Subject: Information on Driver Seat Cushion Design Changes, Driver and Passenger Cushion Appear Different Thickness

Brand:	Model:	Model Year:		VIN:		Engine:	Transmission:
		from	to	from	to		
Chevrolet	Colorado	2019	2019			All	All
GMC	Canyon	2019	2019			All	All

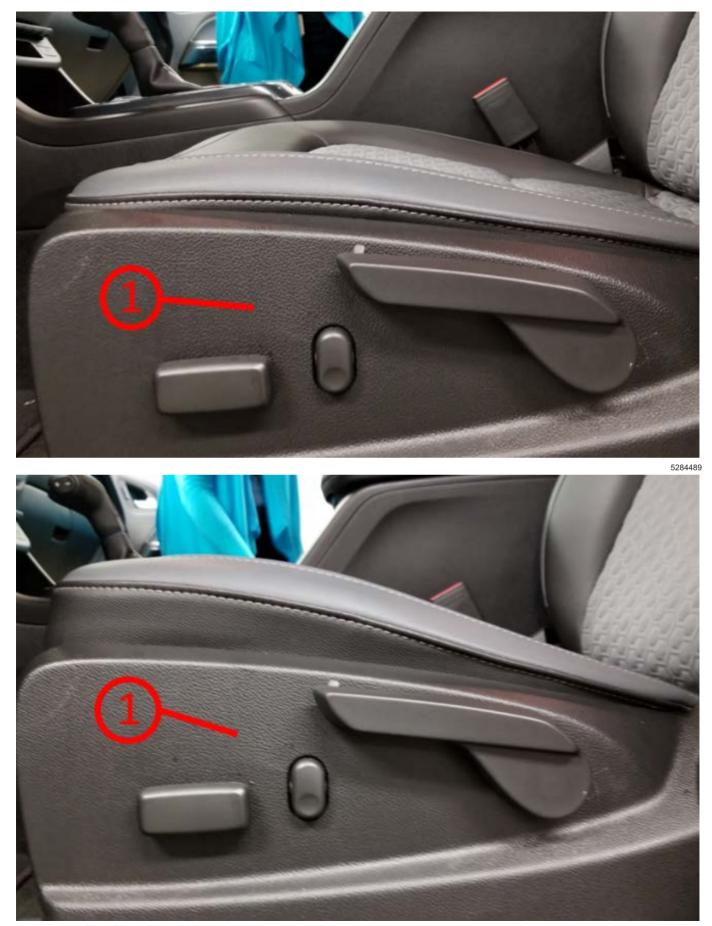
The graphic examples above shows the different appearance in thickness of the driver seat cushion (1) and the passenger seat cushion (2).

The graphic examples above shows the different thickness in the bolster area between the driver seat cushion (1) and the passenger seat cushion (2).

The graphic examples above shows the different thickness adjustments and controls between the driver seat cushion (1) and the passenger seat cushion (2).

Please communicate to the customer this condition is normal design intent for their vehicle. Please share this information with the customer, including a copy of this bulletin.
